PROJECT PHASE:
BID PACKAGE 03

SHEET NUMBER:
S1.02

BASEMENT
FOUNDATION PLAN -
SECTOR 2

College of Osteopathic Medicine
AT THE CHEROKEE NATION
TAHEQUAH, OKLAHOMA

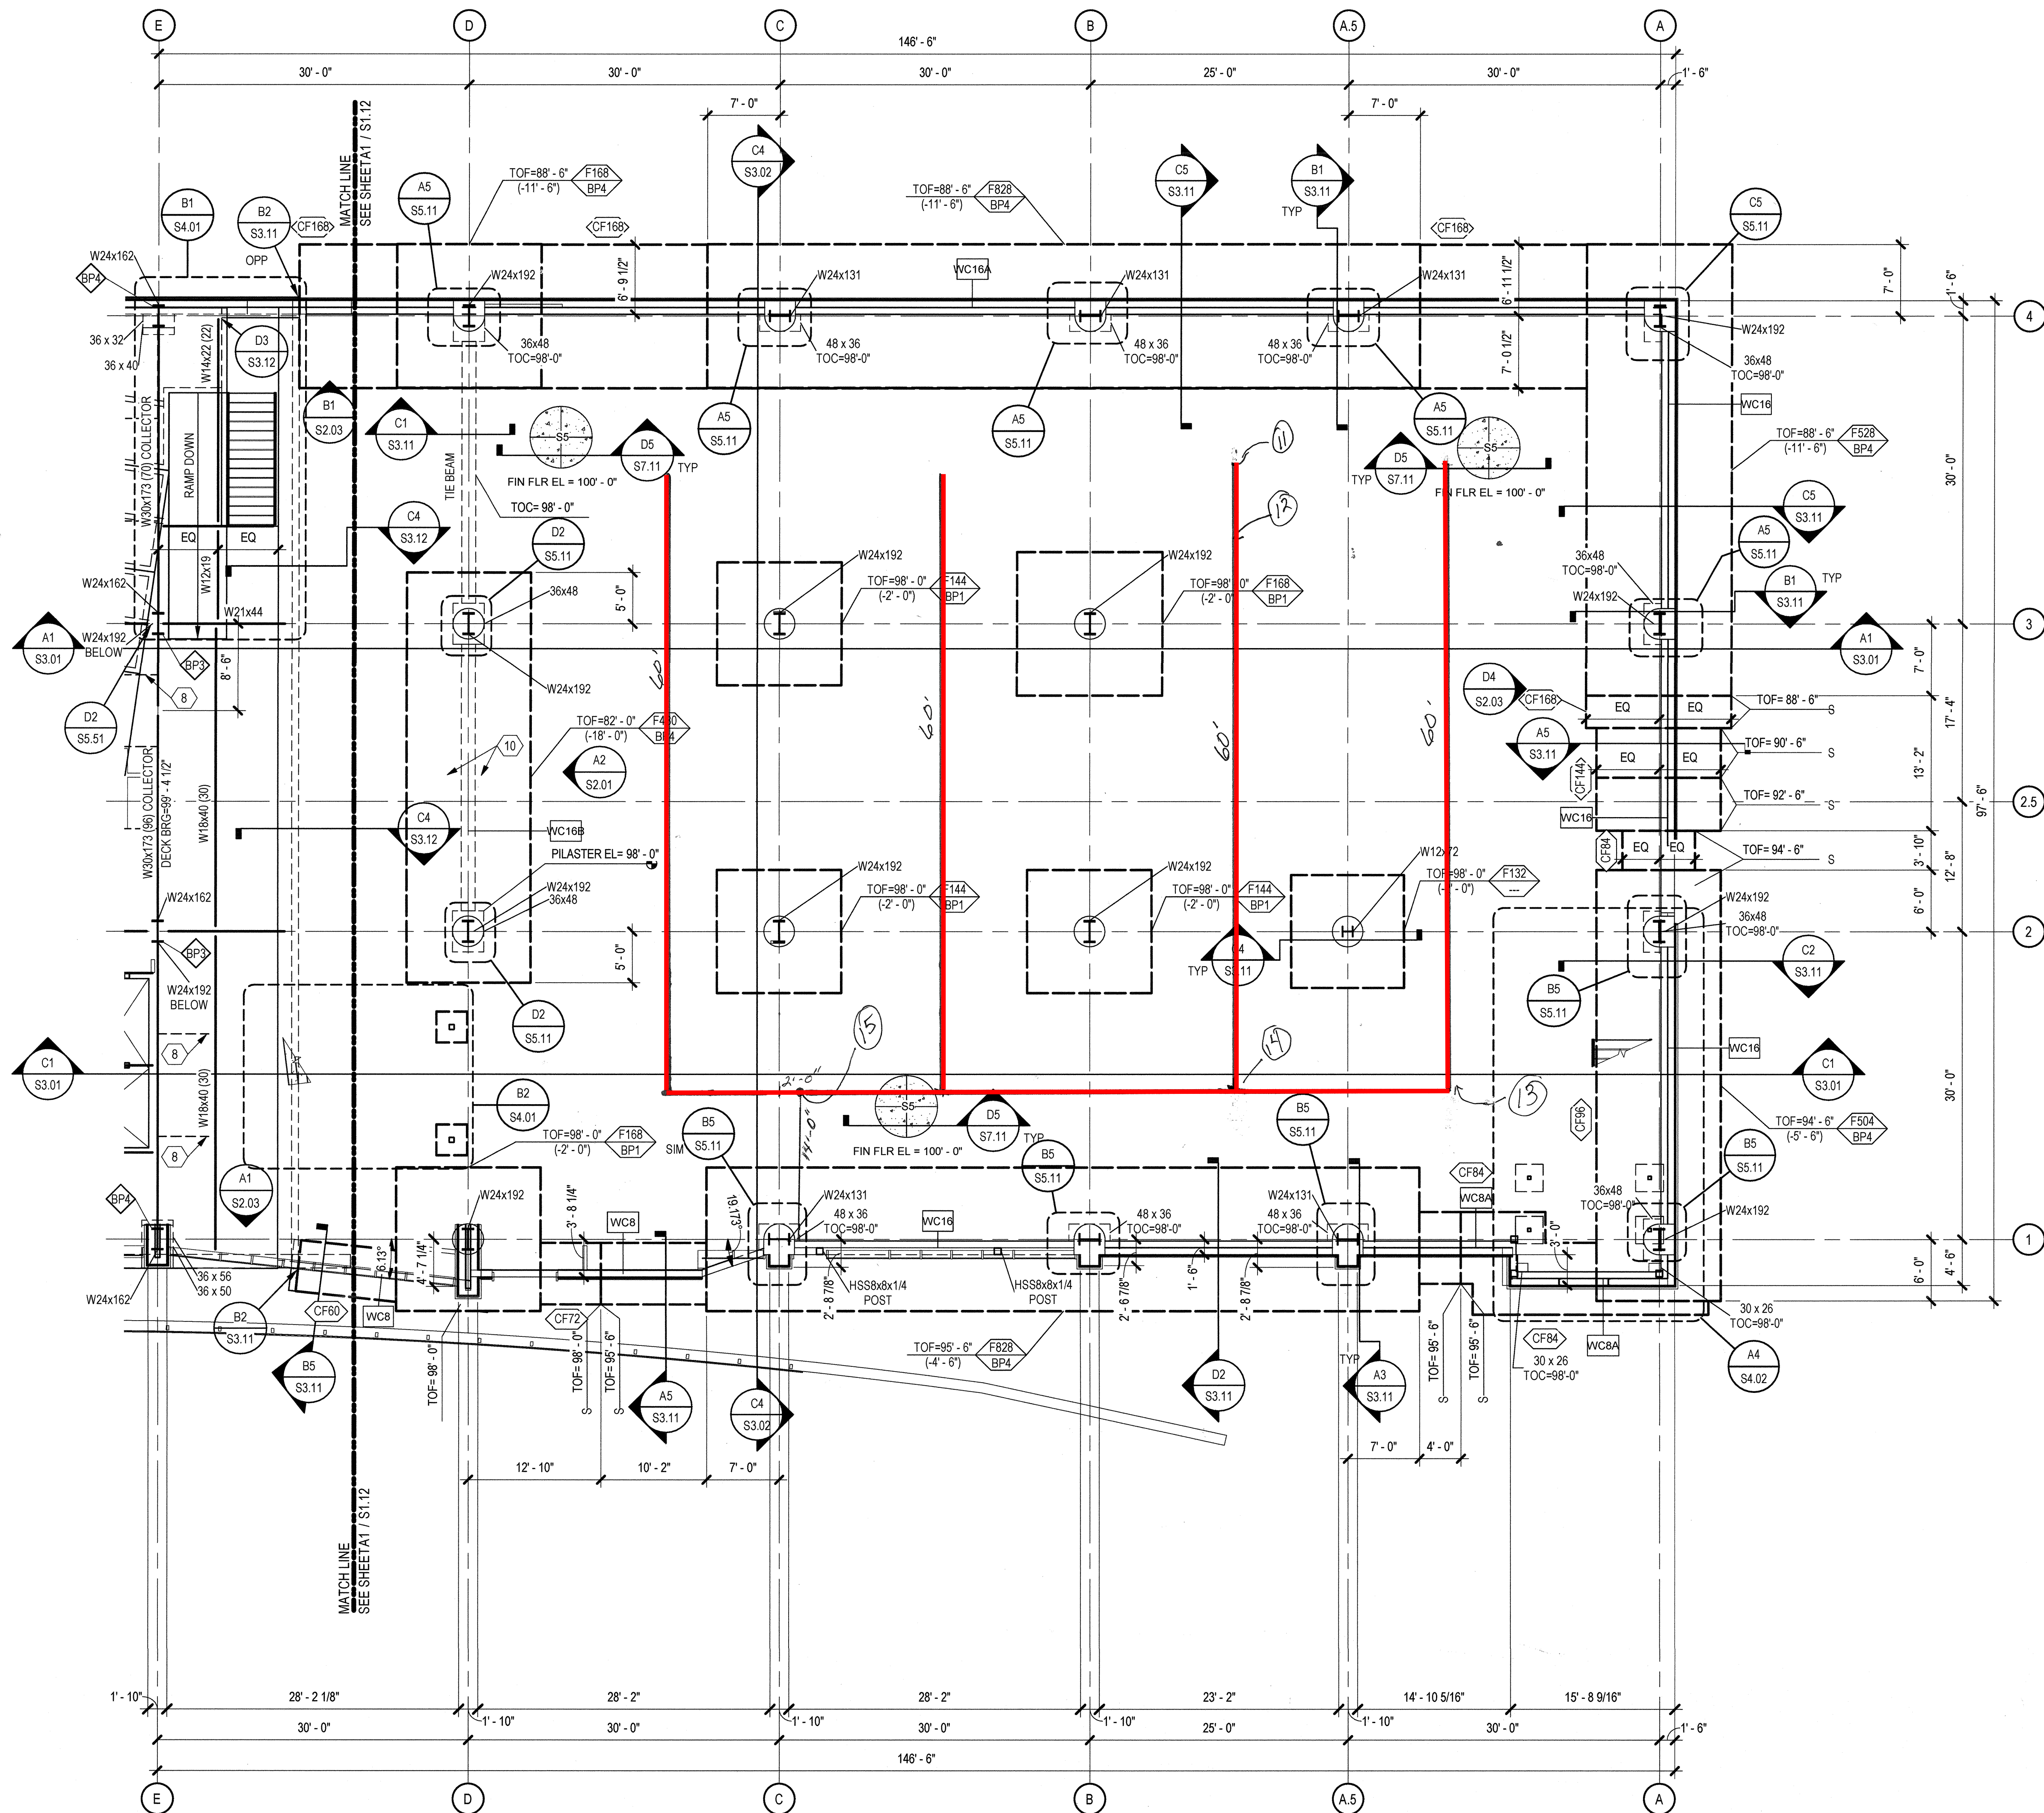
- SITE RETAINING WALL. COORDINATE EXACT SIZE AND EXTENT WITH ARCHITECTURAL AND CIVIL DRAWINGS. SEE RETAINING WALL SCHEDULE A1 / S6.01
- (6) End Caps
- (300) ft. - 3" Flex, Corrugated, perforated, drain Tube with sock

- (2) Tees for above drain tile
- (1) Quad coupling for above tile
- Convert to a 3" Sched. 40 PVC Tee; stub up; place Temp. cap.

01 FLOOR PLAN BASEMENT LEVEL SECTOR 02
1/8" = 1'-0"

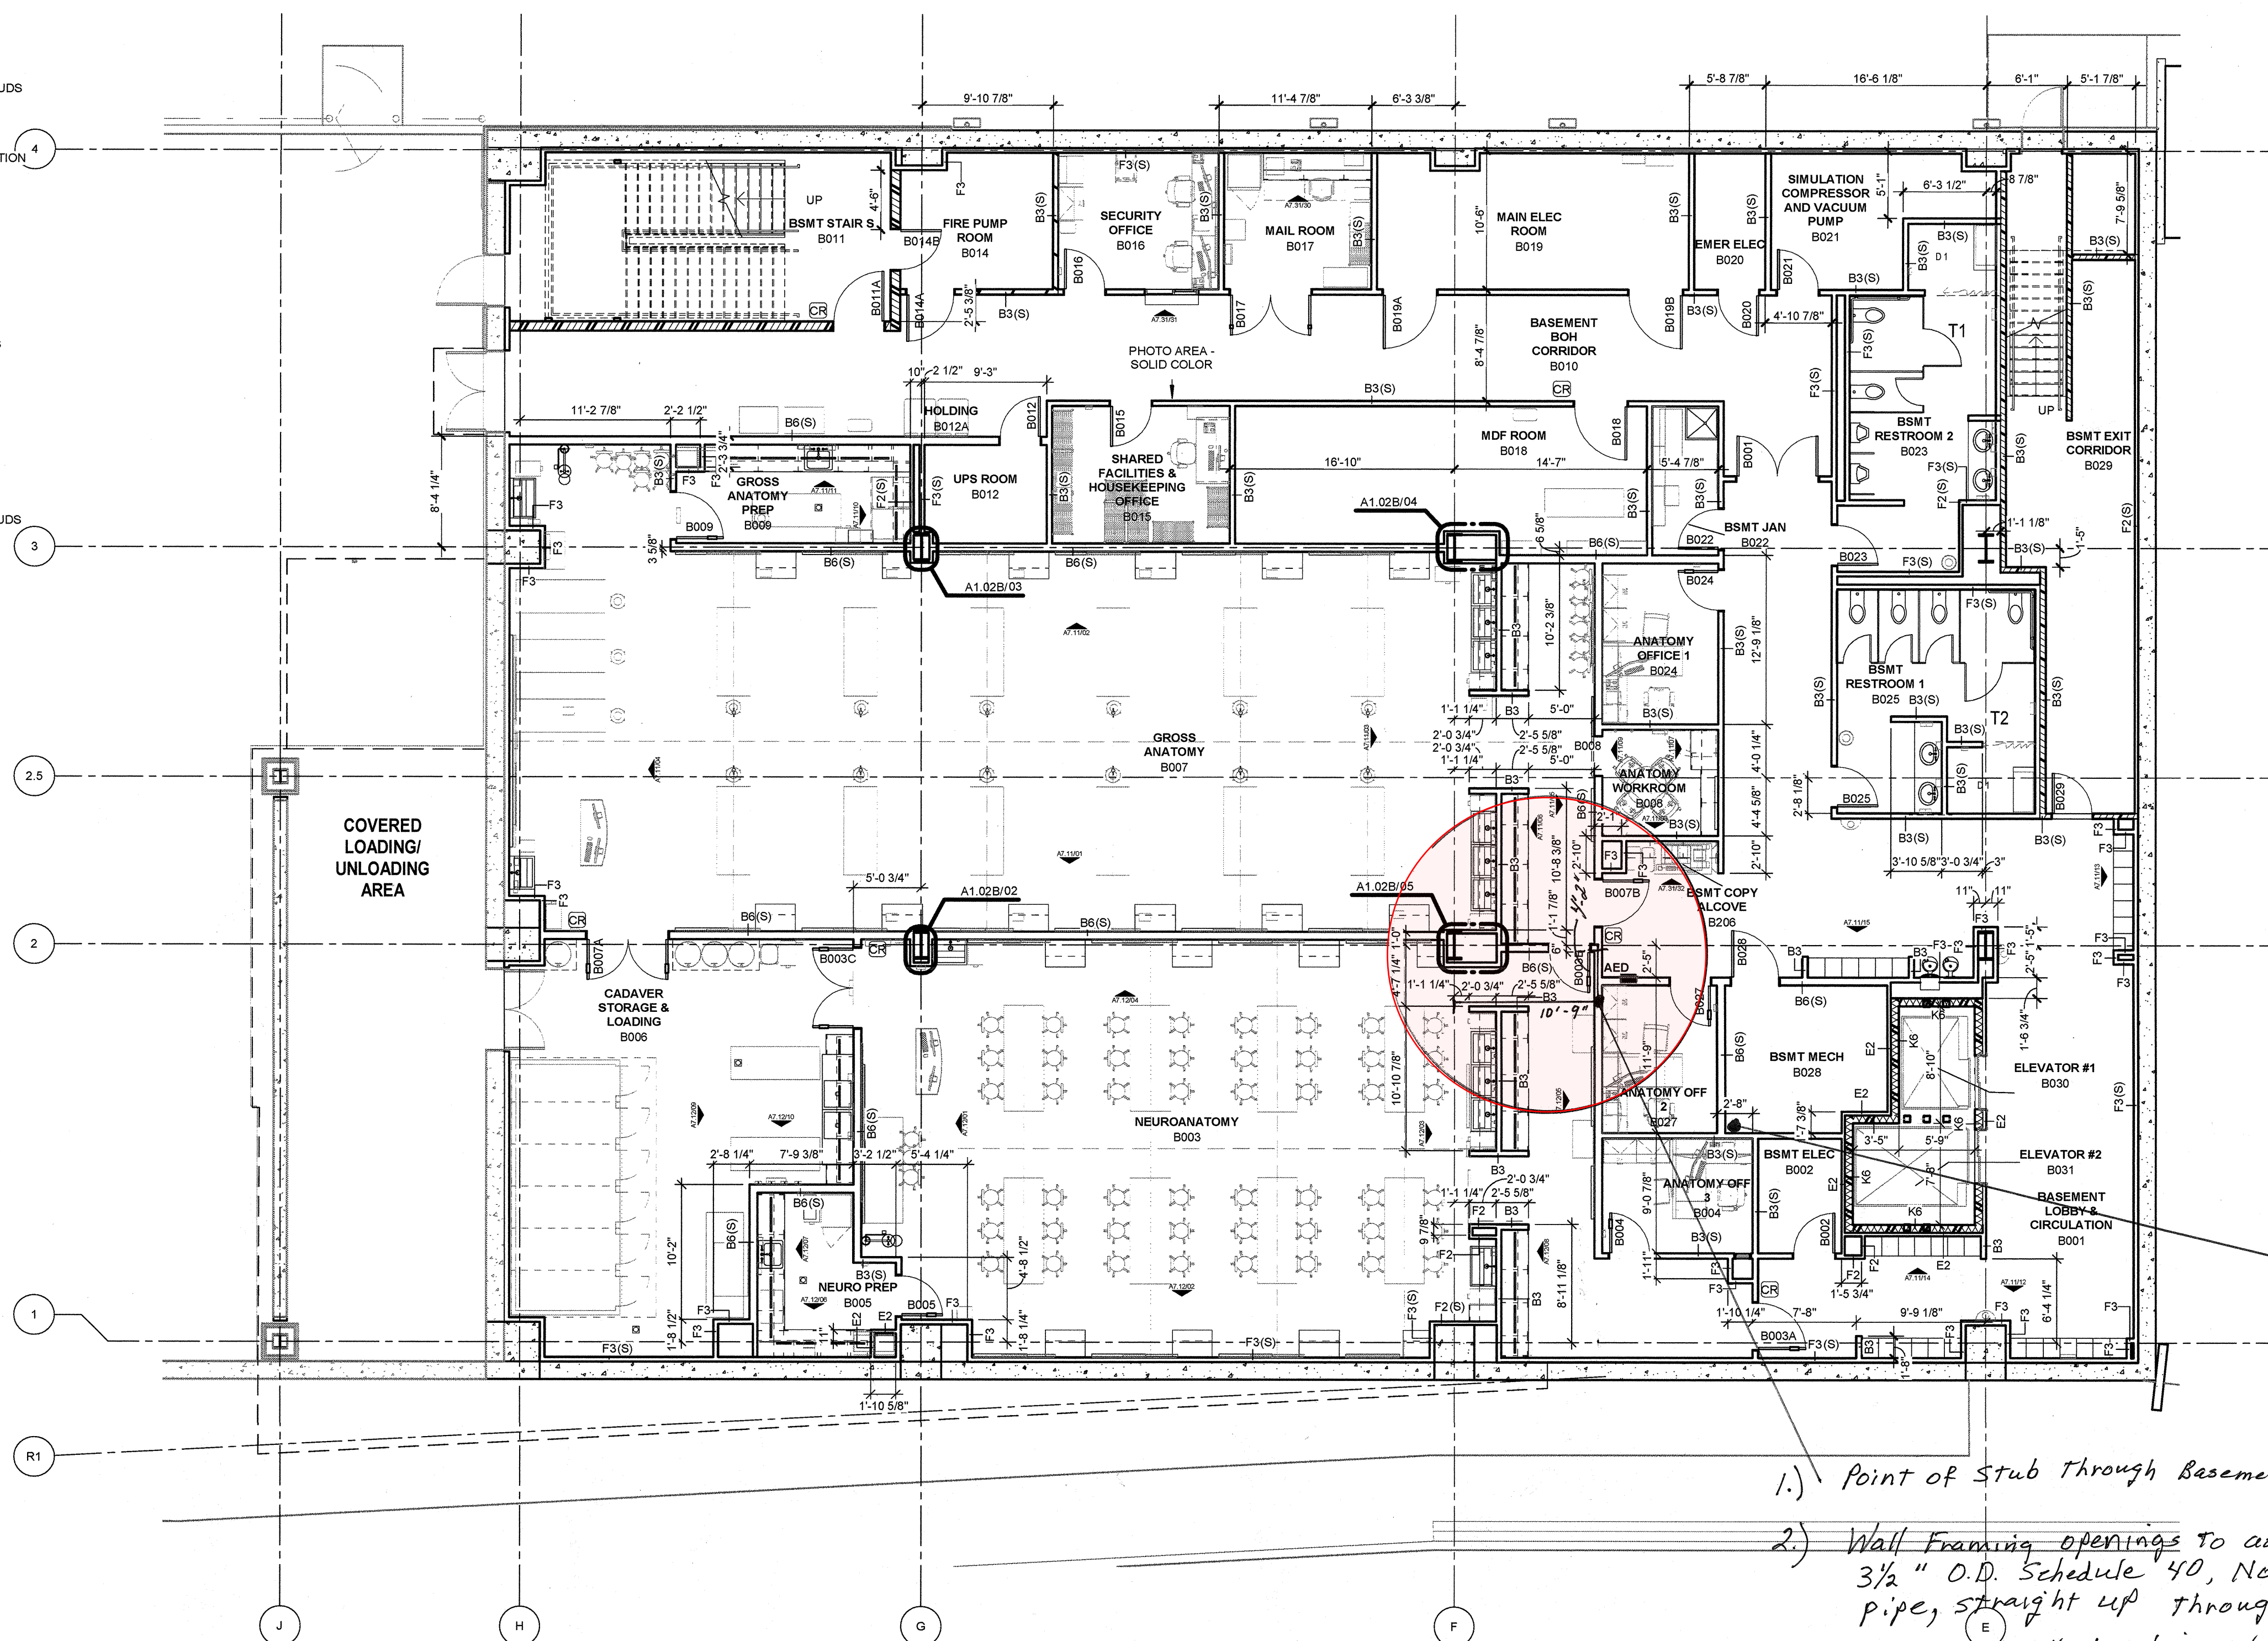
- 1.) Point of Stub Through Basement slab.
2.) Wall Framing openings to accommodate 3/2" O.D. Schedule 40, Non pressure PVC pipe, straight up through this common wall location thru (4) stories.

01 FLOOR PLAN LEVEL 01 SECTOR 01
1/8" = 1'-0"

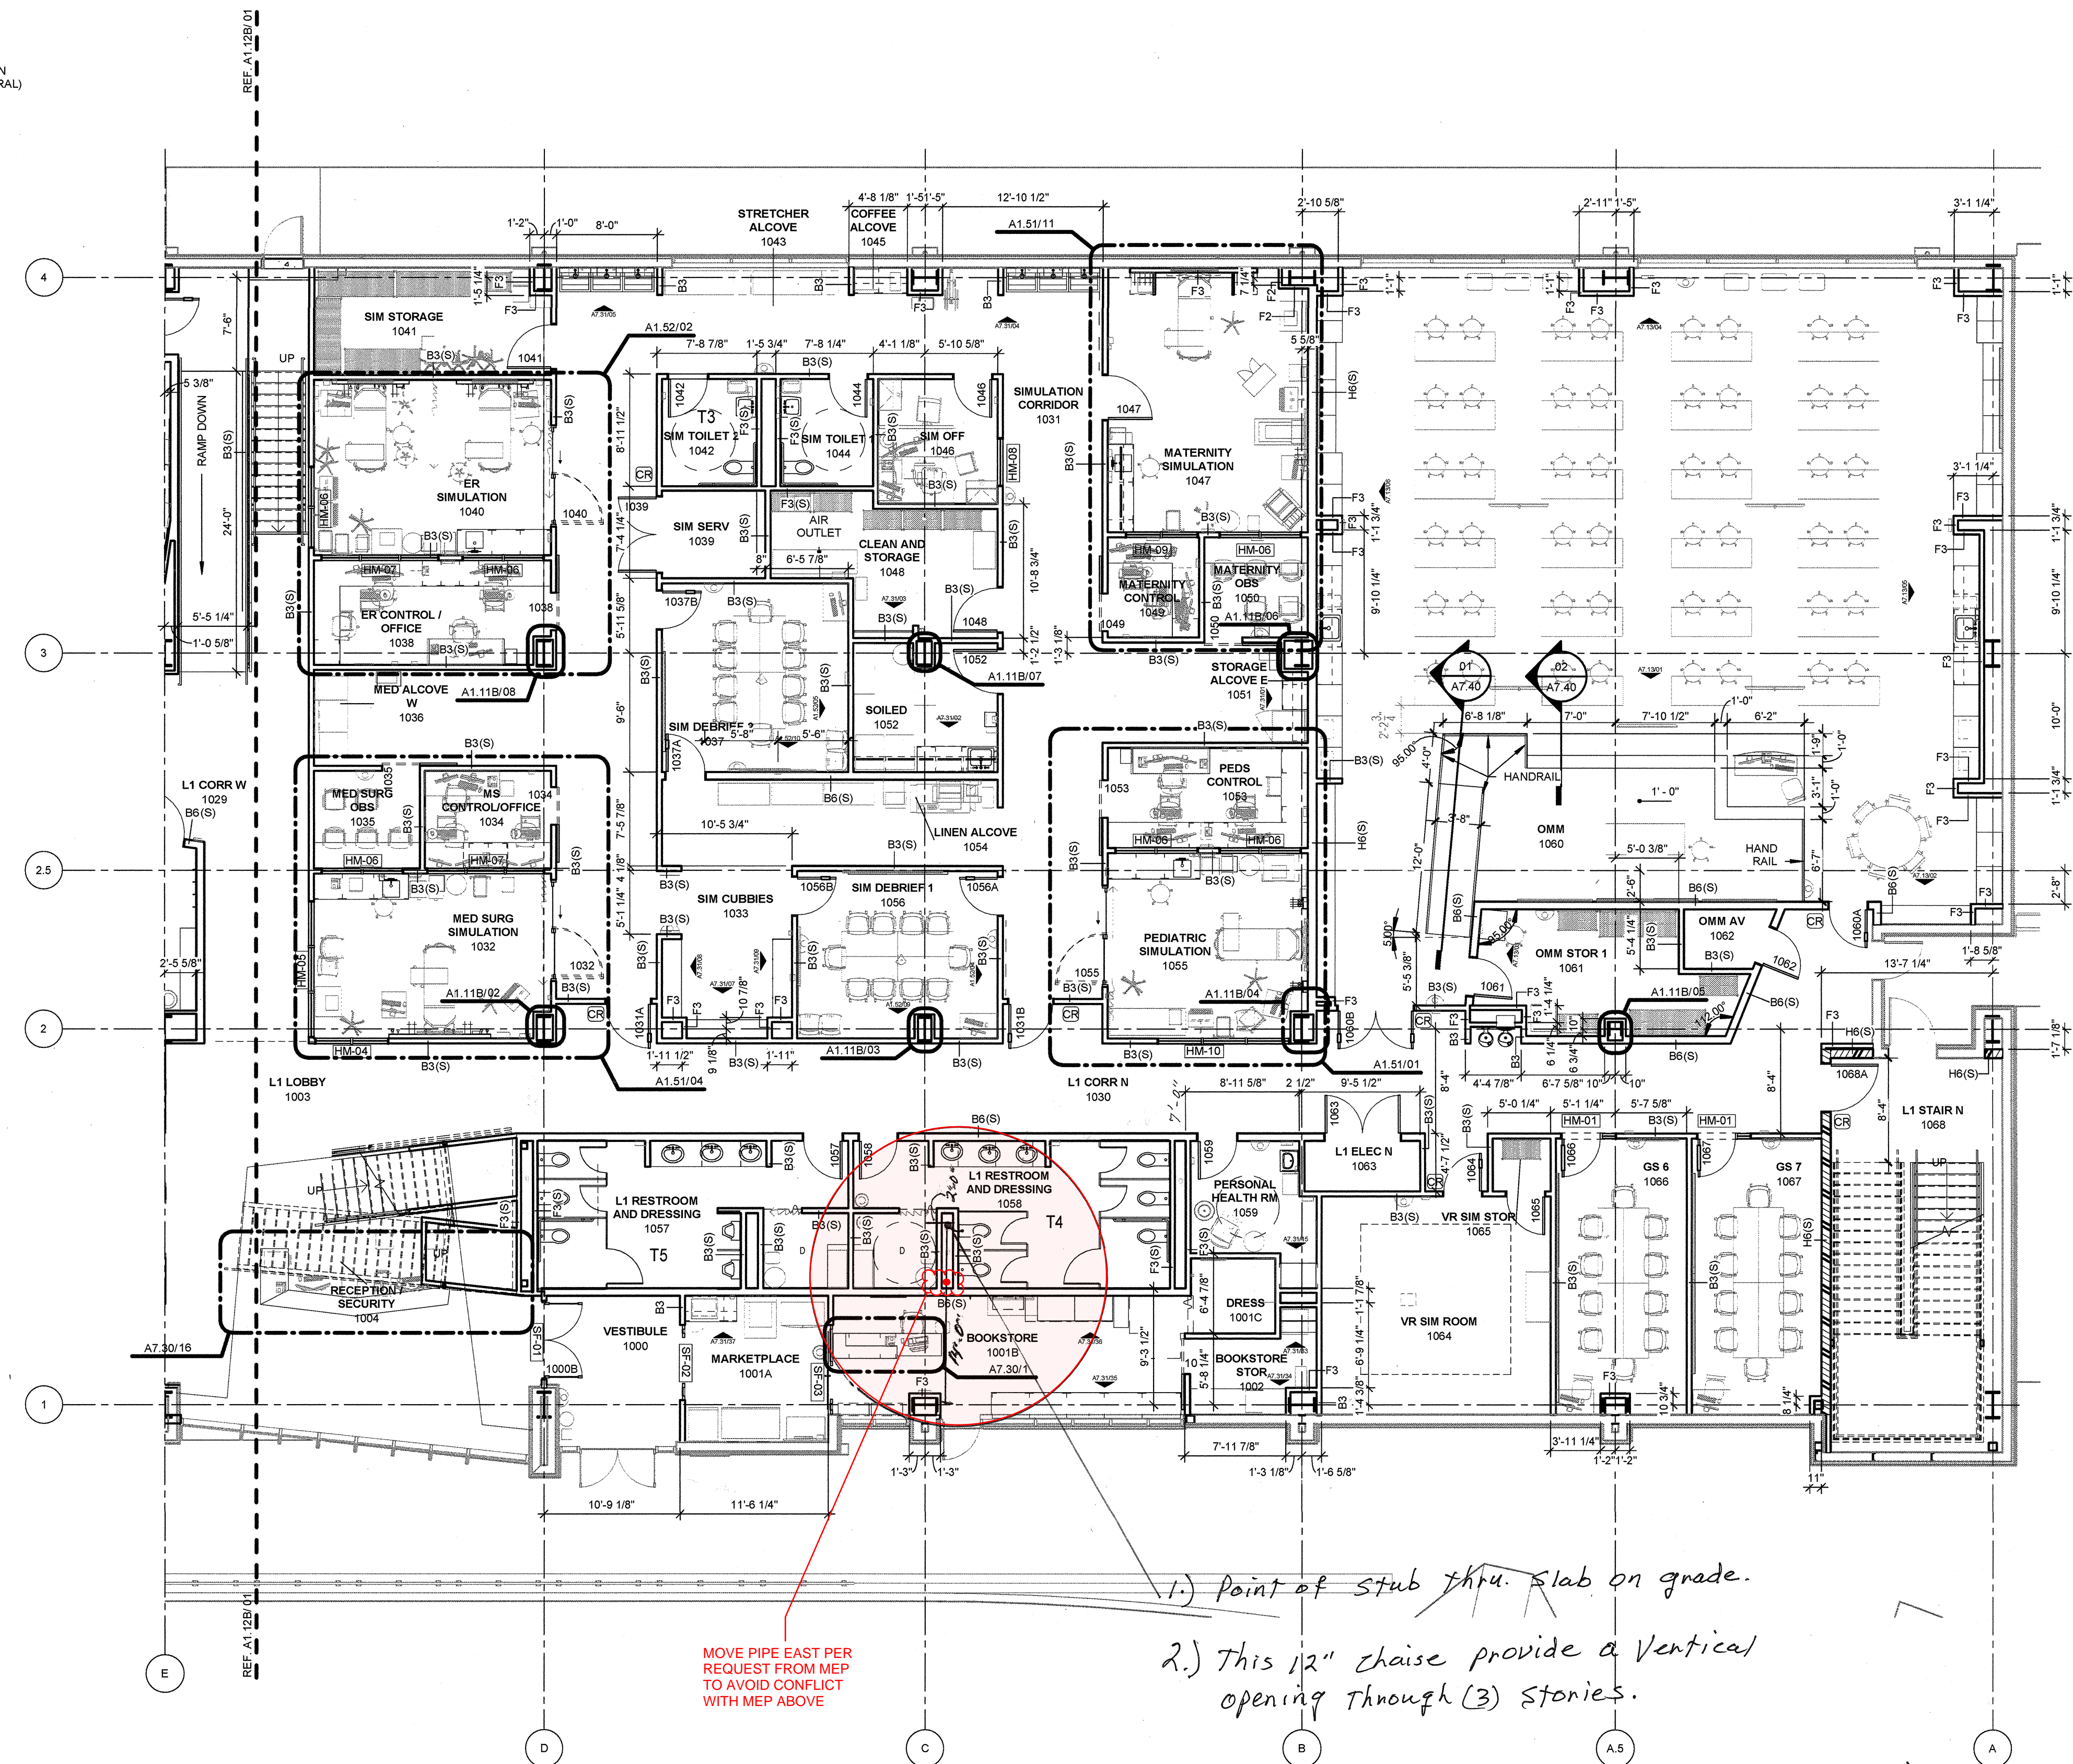
- (4) End Zaps
- (300) Ft., 3" Flex., Corrugated, Perforated, drain Tile w/ sock.
- (2) 90° Couplers
- (2) Tee Couplers
- Convert to a 3" Sched. 40 PVC Tee; stub up; place Temp. zap.
